**SITE PLAN REVIEW SHEET
ENVIRONMENTAL VARIANCE REQUEST ONLY**

CASE: SP-2022-0407D

PROJECT NAME: QuikTrip No. 4141

PROPOSED DEVELOPMENT: Gas station with associated improvements

OVERALL SITE PLAN

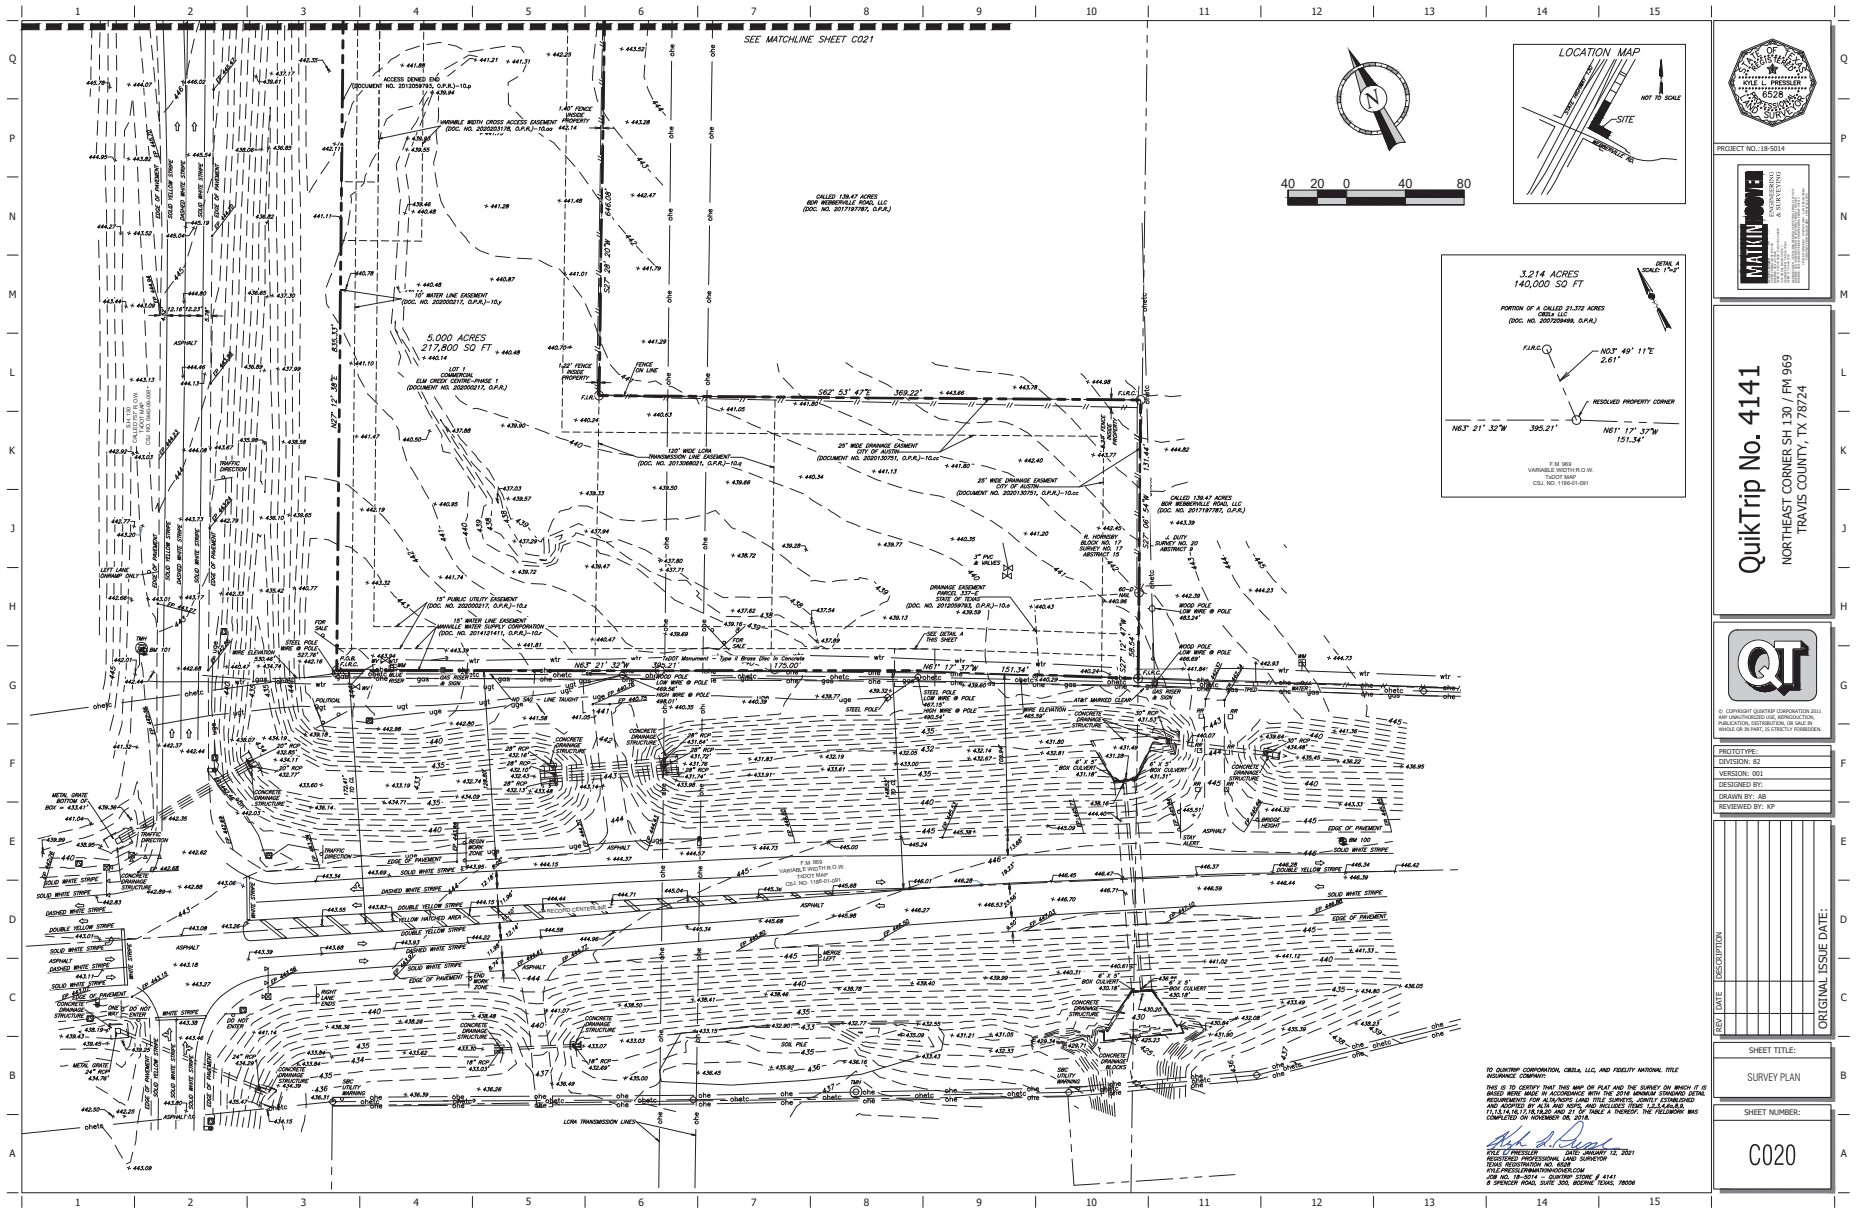
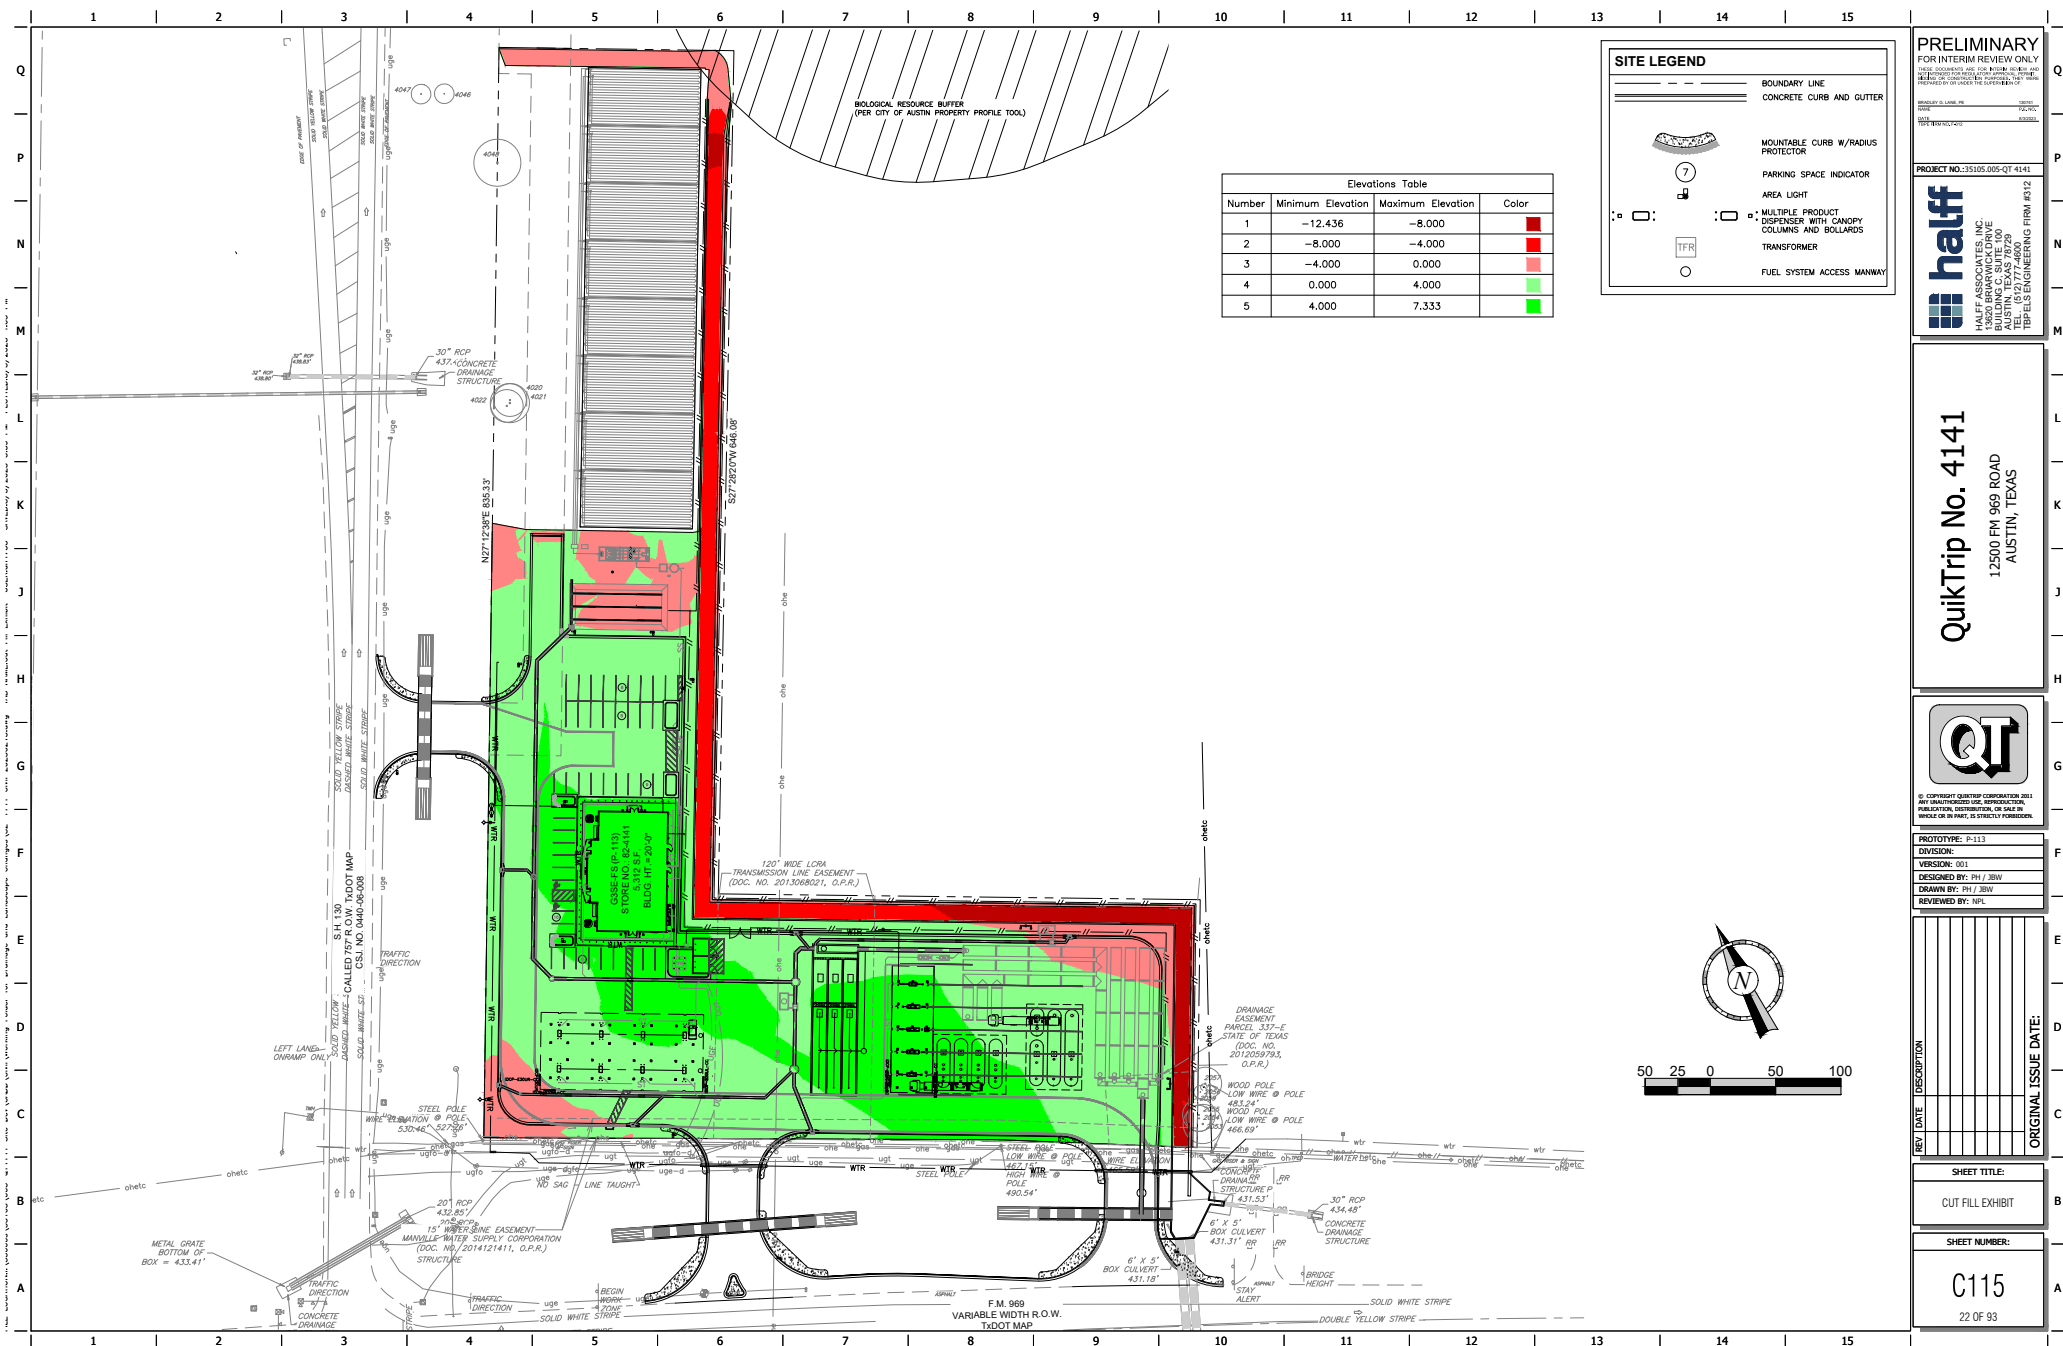
1. Request to vary from LDC
 - 25-8-302(A)(2) to allow parking areas on slopes in excess of 15 percent;
 - 25-8-342 to allow fill greater than 4 feet, to 8 feet, on a slope greater than 15 percent;
 - 25-8-341 to allow cut greater than 4 feet, to 13 feet.

- the deep erosion in the waterway, which has created the steep slopes on which development is restricted.
- The depth of the eroded waterway that must be filled in order to achieve reasonable use of the property.
- The cut needed to create positive flow for the drainage bypass channel.

Yes / No The site plan for this development meets the requirements for water quality and detention. A rain garden has been added to the plans, and native landscaping is proposed. All cut/fill will be structurally contained, minimizing the potential for erosion. The proposal does not create a significant probability of harmful environmental consequences.

Onsite Rain garden

Landscaping (Landscaping is not required in the ETJ.)

- The addition of 51 native/adapted trees to the site.
- The addition of 486 native/adapted shrubs to the site.
- The replacement of all Bermuda sod with 609S seeding.
